TO:	CHAIR AND MEMBERS – PLANNING & ENVIRONMENT COMMITTEE
FROM:	GEORGE KOTSIFAS, P.ENG MANAGING DIRECTOR, DEVELOPMENT & COMPLIANCE SERVICES & CHIEF BUILDING OFFICIAL
SUBJECT:	APPLICATION BY: RICHMOND MEDICAL CENTRE INC. 1653 RICHMOND STREET PUBLIC SITE PLAN MEETING MAY 19, 2015

REQUESTED ACTION: Approval of an application for Site Plan Approval for the construction of a four (4) storey mixed use building containing 430 square metres of medical offices and nine (9) apartment units

Current Site Plan

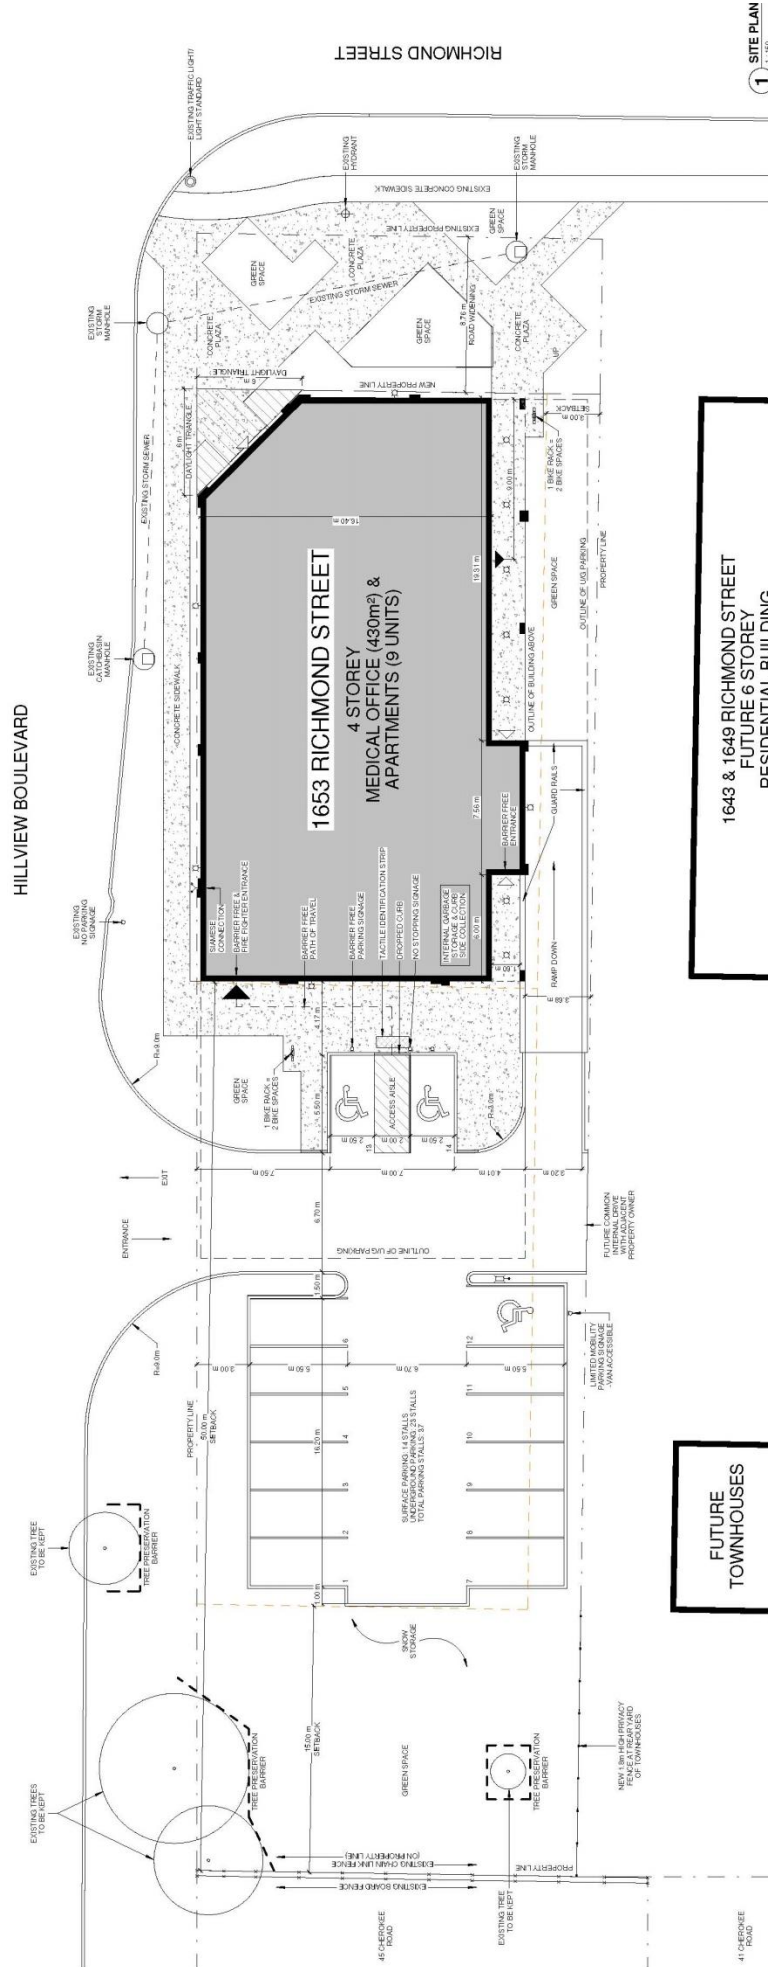
- Prohibit left turns existing onto Hillview Boulevard with a 1/2 porkchop with signage in accordance with the access management guidelines.
- Add a note to site plan indicating that "no stand alone signage proposed".
- Add a second "no stopping" sign to barrier free ramp & no stopping sign detail to the site plan.
- Add details of all signage proposed (i.e. no left turn)

Original Tree Preservation Plan

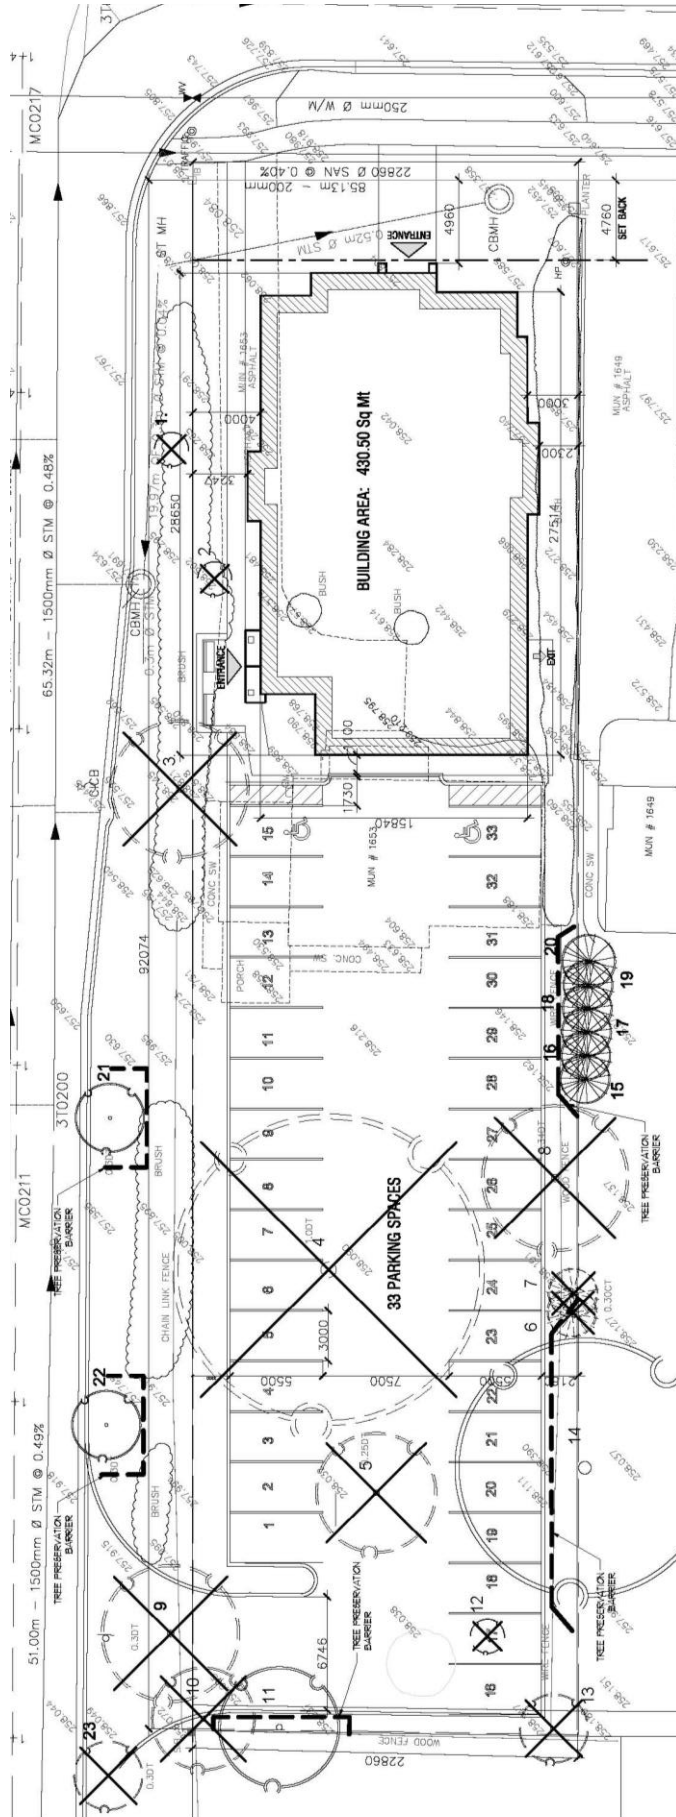
- Prepare a reference plan for the road widening dedication 8.76m required along Richmond Street as well as a 6mx6m daylight triangle. Submit a draft reference plan for review by Geomatics prior to having it deposited at the registry office.
- Provide external works drawings for the construction of left turn lane off of Hillview Boulevard and provide pavement marking drawings required.
- Add clusters of shrubs and trees in the green space west of the parking area.
- Consensual tree removals required to remove boulevard trees and shrubs. (Tree #'s 1, 3, 9 and 23 + existing shrubs identified in original Tree preservation plan).

Current Building Elevations

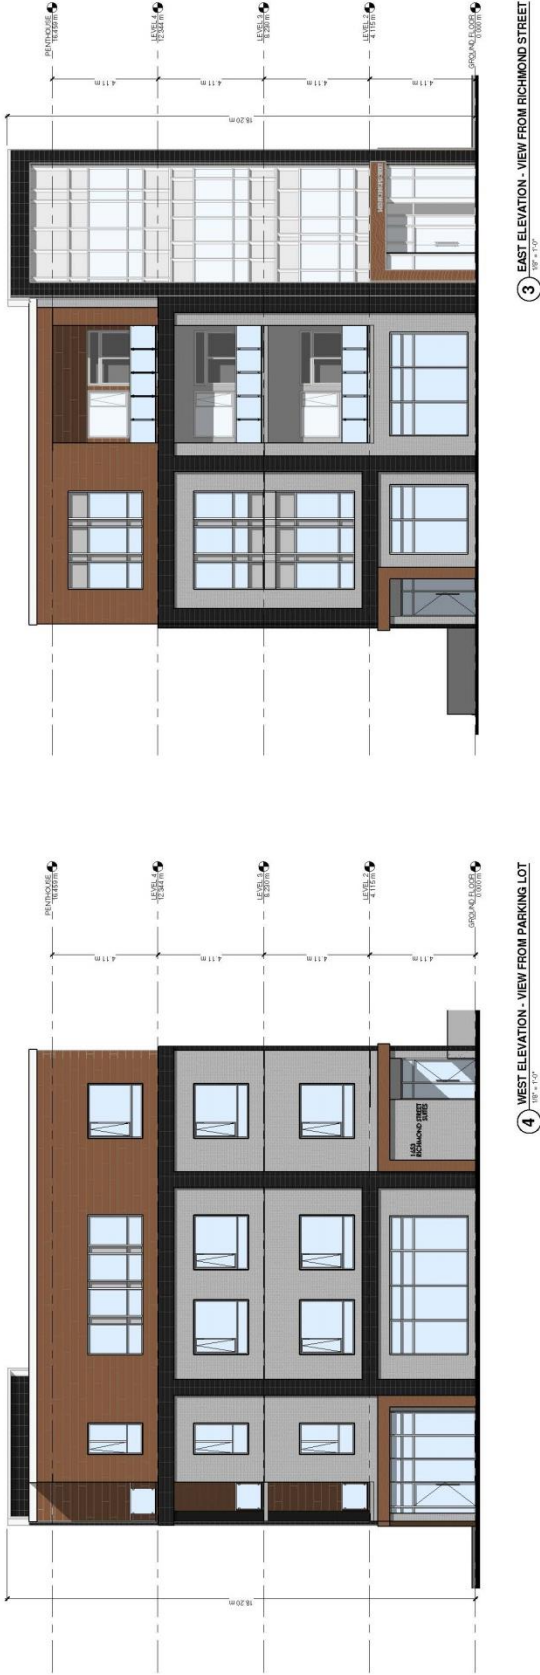
- Modify the width of the window bays on the north facade to make them the same width, this would help to balance this facade. Suggest splitting the difference between the two(four) bays as opposed to going to the wider bays.
